Re: Resource Recovery and Protection Plan (R2P2) Modification,  
Aberdeen Mine, Main East Seals

**MINOR MODIFICATION TO  
MINING PLAN APPROVED BY  
BUREAU OF LAND MANAGEMENT**

**LOCATION OF  
PROPOSED SEALS**

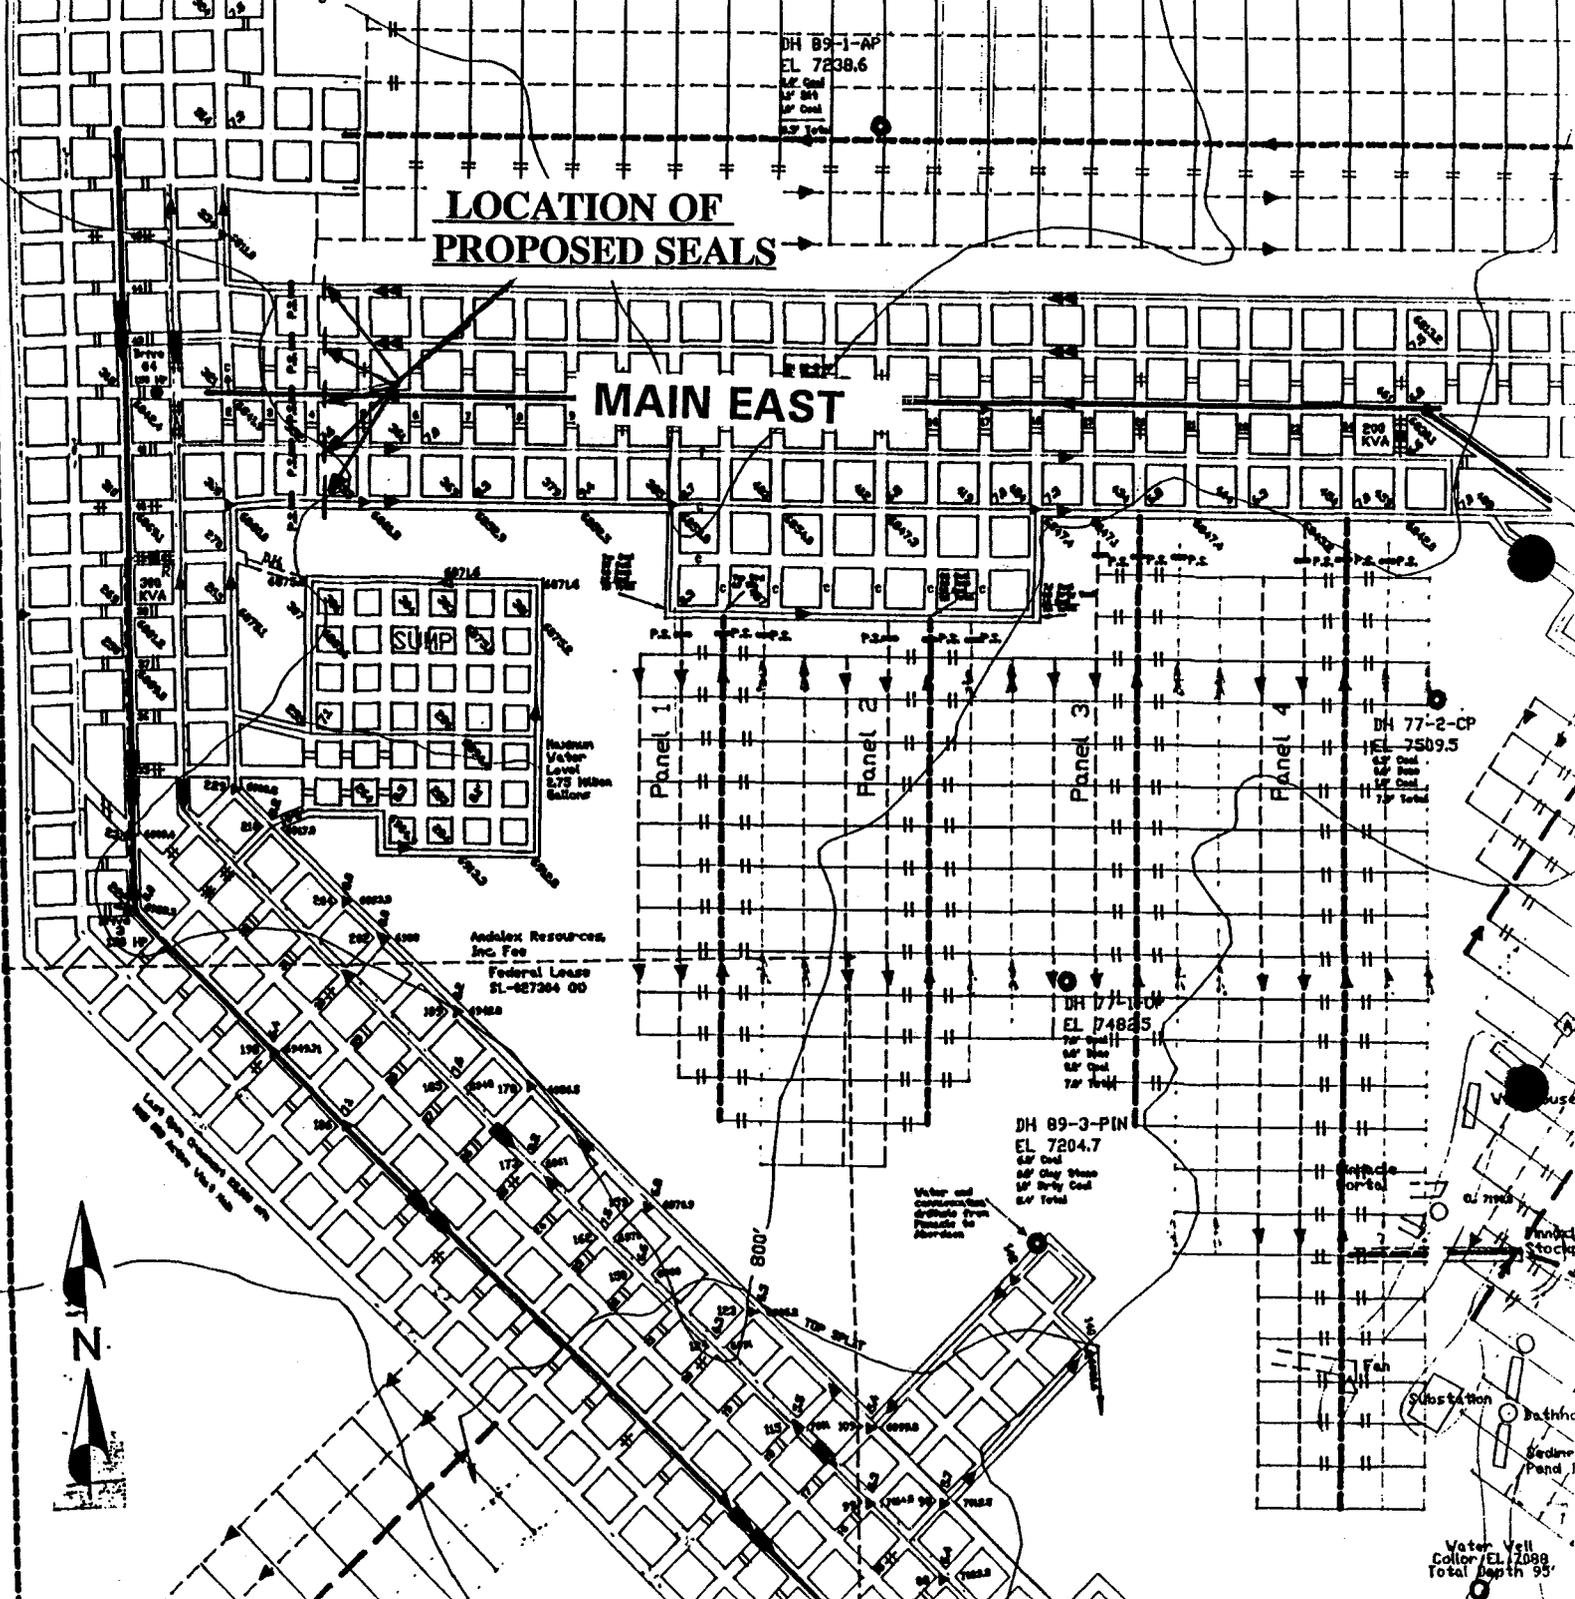
The approved R2P2 for the Aberdeen Mine indicated that Andalex would gain access to the Upper A Seam through the Main East section. On May 20, 1992, approval was given to discontinue advancement of the Main East section. Andalex now proposes to seal the Main East entries (Enclosure 1) because ventilating it would result in higher mining costs. These costs include: 1) maintaining approximately 3.5 miles of entries to the standards of Mine Safety and Health Administration; 2) construction of three overcasts through five feet of rock in three intersections; and 3) increasing the volume of air to ventilate this section of the mine.

We agree that sealing Main East will reduce mining costs by eliminating the added ventilation, inspections, maintenance, and roof control in this section. We also conclude that the proposal will not negatively impact the recovery of Federal coal. The possibility of accessing the Upper A Seam through Main East still remains. Furthermore, sealing this section will not significantly affect the good conditions that exist before Andalex attempts to access the Upper A Seam again in 1998.

maximum economic recovery of the Federal coal. Therefore, the proposed modification is hereby approved.
